RO Questions 1 to 75

This is our second submission for the December 2005 ILO exam. These are 75 questions of a 75 question RO exam and a 100 question SRO exam. The 75 questions submitted hereunder are all considered RO level examination questions.

Facility: Susqu	ehanna	Stea	am E	Elect	ric S	Statio	<u>on</u>		Date	of	Exar	n: <u> </u>	12 to 22	D	ece:	mbe	r 20	<u>05</u>
			F	RO K	/A C	atego	ory Po	oints						S.	RO-	ONI	LY P	oints
Tier	Group	K1	K2	К3	K4	K5	K6	A1	A2	A3	A4	G*	TOTAL	K	<u>A</u>	A2	G*	TOTAL
	1	4	3	3				4	3			3	20					8
1. Emergency & Abnormal Plant	2	1	2	1				1	1			1	7	-	_			4
Evolutions	Tier Totals	5	5	4				5	4			4	27					12
	1	3	2	2	3	2	2	3	3	2	2	2	26					4
2. Plant Systems	2	1	1	1	1	1	1	1	1	2	1	1	12	-				2
	Tier Totals	4	3	3	4	3	3	4	4	4	3	3	38					6
3. Generic Knowle	edge and	Ahilit	ties			1	2	2	3	3	4	4		1	2	3	4	
Categories	cago ana .	. 101111	.100			2		3		2		3	10					7

3 RO SRO Question ID: 28347 Origin: Bank Memory Level

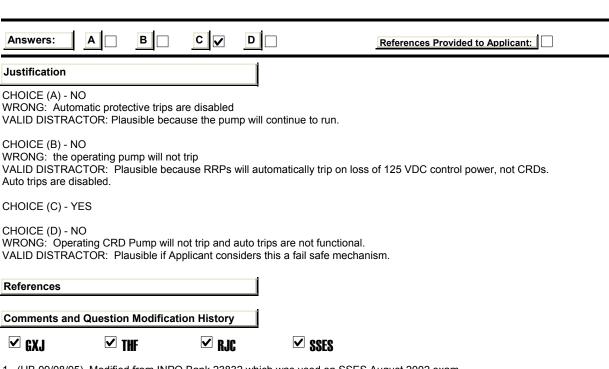
- 1. (HB 09/08/05) Modified from INPO Bank 23832 which was used on SSES August 2002 exam.
- 2. THF 09/08/05 changed format to T-T / T-F / F-T / F-F with reasons.
- 3. Gil 09/09/05 question ok but in ATWS and directed to start both CRD pumps. Concurrent loss of DC power. Now what?
- 4. Gil 09/26/05 could not validate with enclosed references.

R: need SSES to validate answer and distracters. Low risk of error because this is a bank question. Gil thinks it's reasonable from memory.

- 5. Todd 09/30/05 OK.
- 6. SQ 10/14/05 Move "The operating CRD pump will . . . " to the stem and delete from each answer choice. Stick to one pump R: done
